Operations Bulletin

Bulletin 105

Filter Monitors

11 Dec 2017

Appendix 3 - Comparison of 60 and 100 mesh sizes for strainers

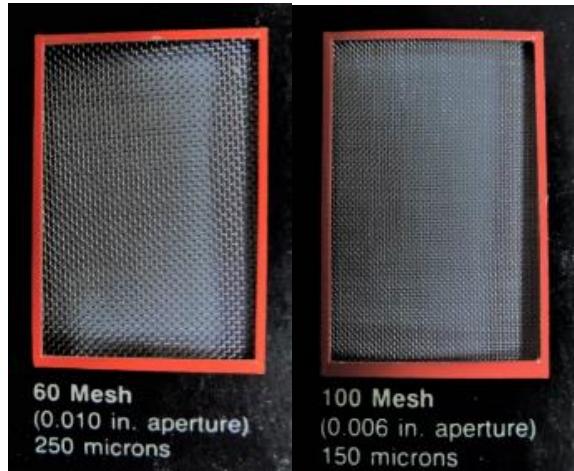
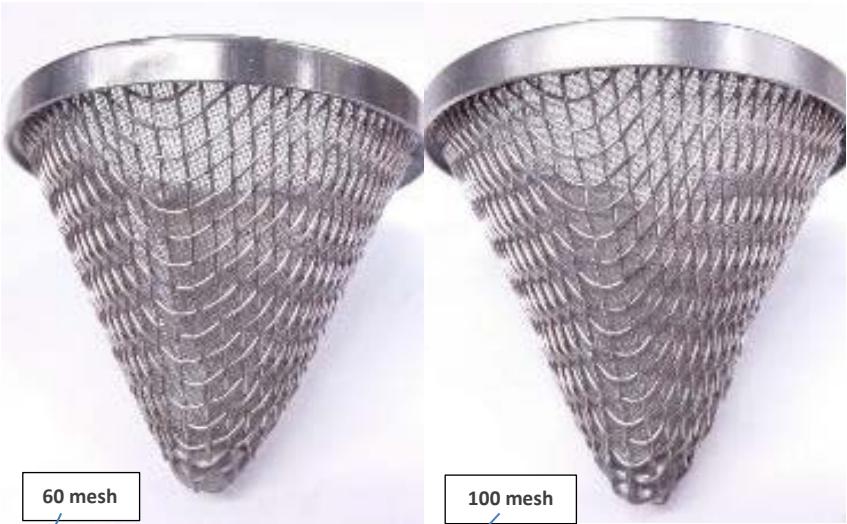
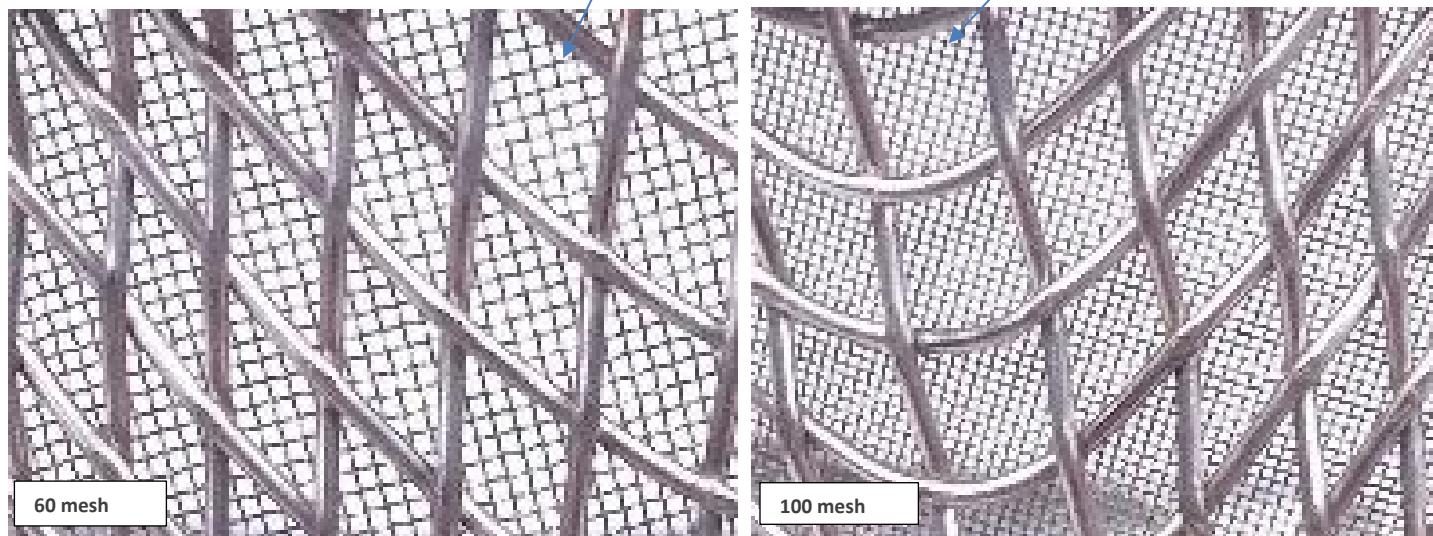
- On vehicles fitted with filter monitors where the hose-end strainer will change from 60mesh to 100mesh, as defined in the table of actions below, it is recommended that each venturi circuit is checked and re-adjusted, if necessary, during the next scheduled check of the PCVs (for compensated systems)

5	Adjust the activation point of DP switches currently fitted on all filter monitor vessels to 15psi (1.0 bar), in accordance with the equipment manufacturers' procedures.	JS	31/1/2018
6	If not already in place, change all hose-end strainers on fuelling equipment fitted with filter monitors to 100 mesh size.	JS	31/1/2018
7	All 2" filter monitor elements in service shall be compliant to EI 1583 7 th edition	JS	30/6/2018
8	All 6" Out to In (direction of flow) filter monitor elements in service, that cannot be converted to an EI 1581 6 th ed. FWS, shall be compliant to EI 1583 7 th edition. Note: If the due date cannot be met due to limited supply options of EI 1583 7 th ed. 6" elements, a revised due date will be considered by JIG in a future JIG Bulletin.	JS	30/6/2018
9	Regardless of their element flow configuration, all converted filter monitor systems (i.e. converted from a previous FWS configuration) with 6" filter monitor elements shall be re-converted to EI 1581 6 th edition FWS, with advice from the filter manufacturer	JS	30/6/2018

(6) See also Appendix 3 in this Bulletin
